Re: TFN 5 4/277 Technical Review Nichols Ranch Unit Production Area #1 (PA#1) Wellfield  
Data Package, Uranerz Energy Corporation, Permit No. 778

**TFN 5 4/277 Technical Review Nichols Ranch Unit Production Area #1 (PA#1)  
Wellfield Data Package**

**Technical Review Comment Responses**

FIGURE 6-4. DEPTH TO WATER VERSUS TIME FOR OVERLYING AQUIFER WELL MON-12

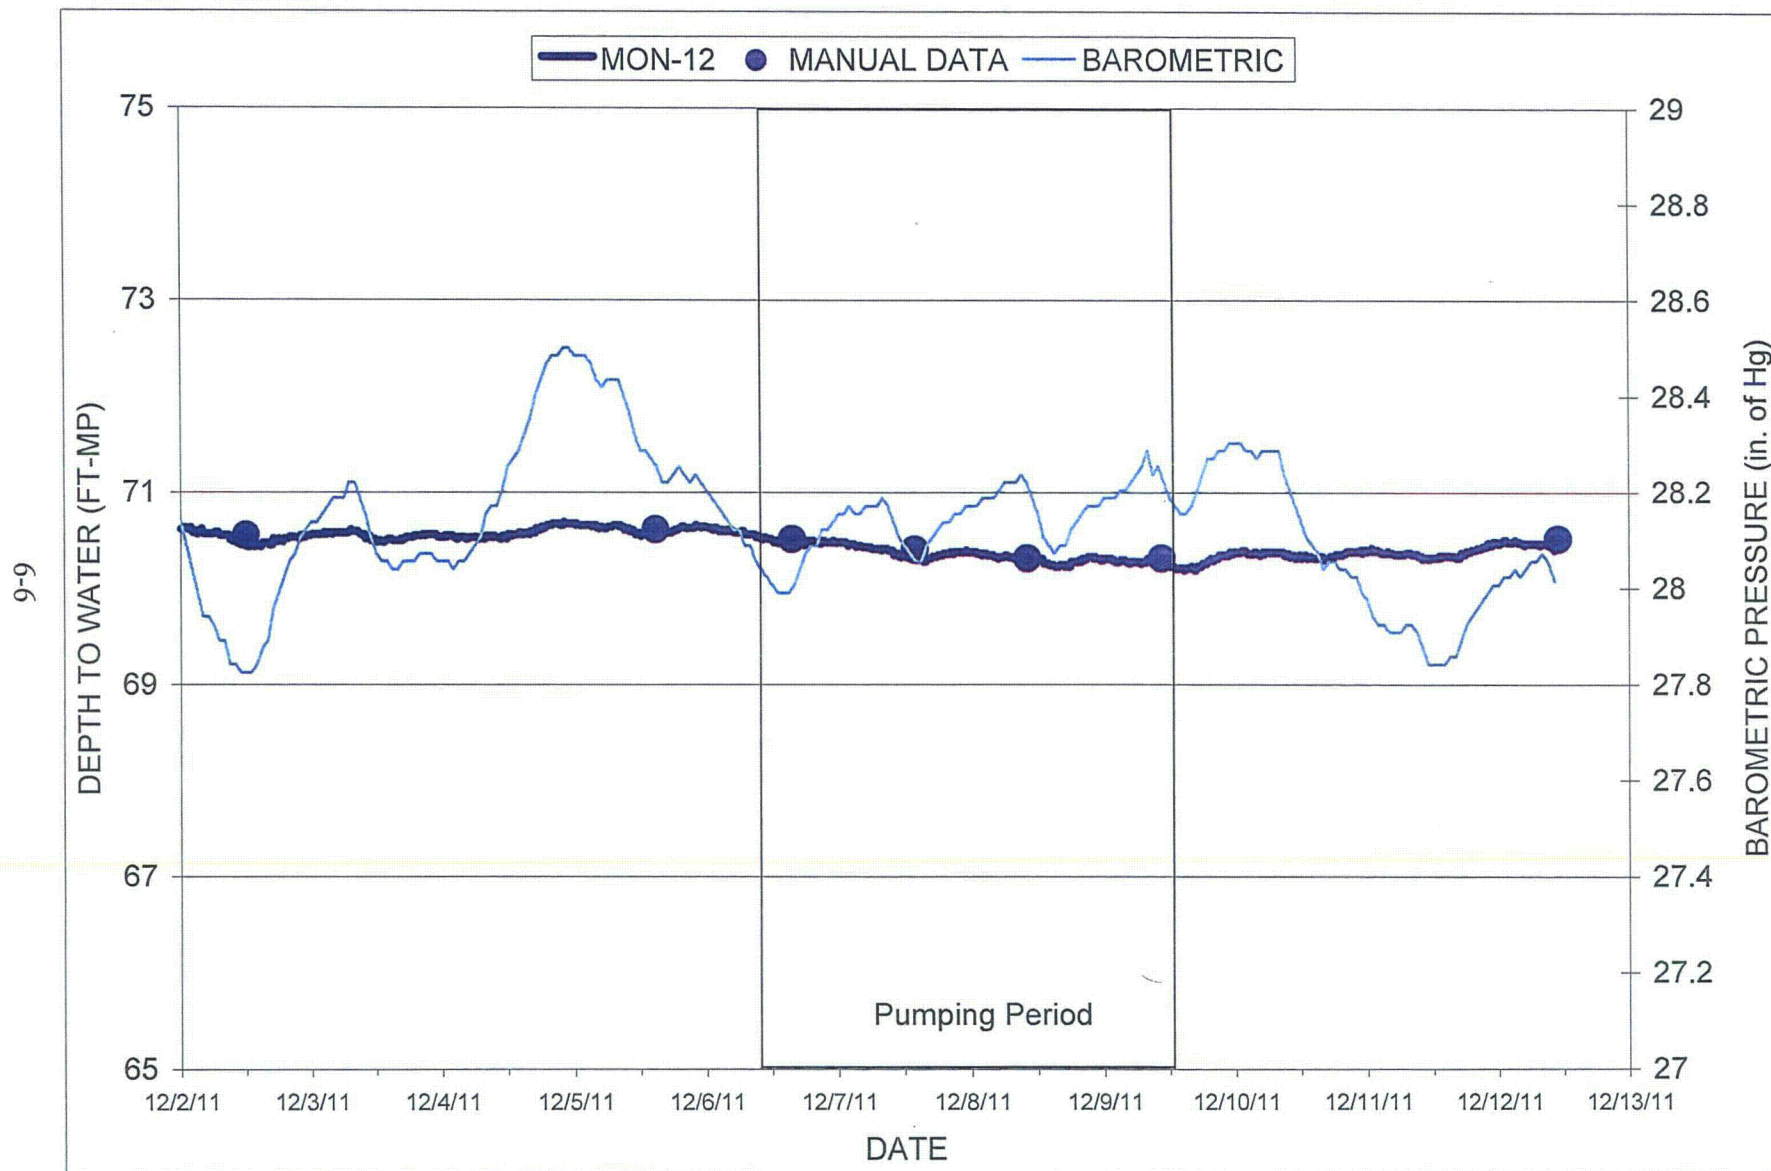
2. Section 6, MRN-23 Test, Figure 6-4, pg. 6.6: I hand-corrected the legend on this figure to read "Well MON-12" rather than "Well MON-2". (MT)

*Figure 6-4, pg. 6.6 has been revised to read Well MON-12. The revised figure is enclosed.*

FIGURE 7-14. DEPTH TO WATER VERSUS TIME FOR OBSERVATION WELL MRN-33

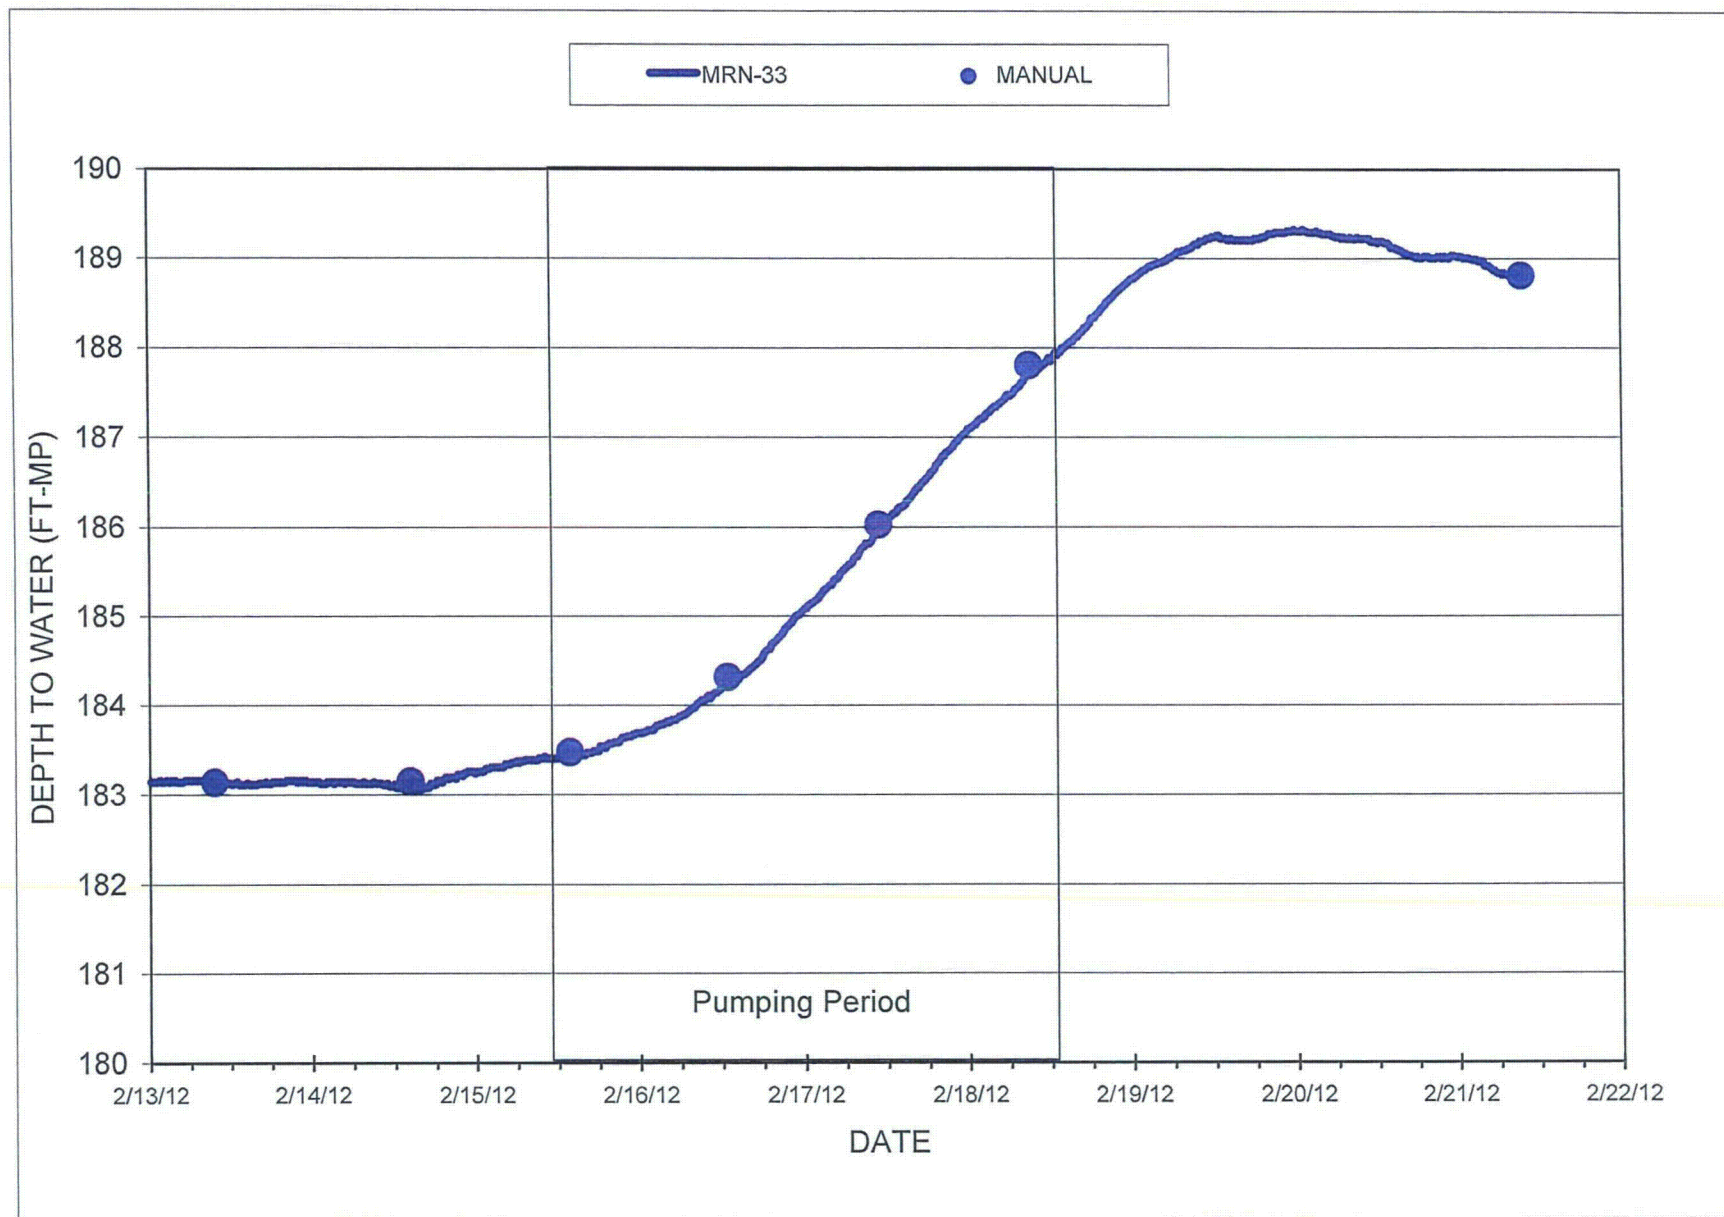
3. Section 7, MRN-29 Test, Figure 7-14, pg. 7.19: I hand corrected the legend on this figure to read "Well MRN-33" rather than "Well MRN-3". (MT)

*Figure 7-14, pg. 7.19 has been revised to read Well MRN-33. The revised figure is enclosed*
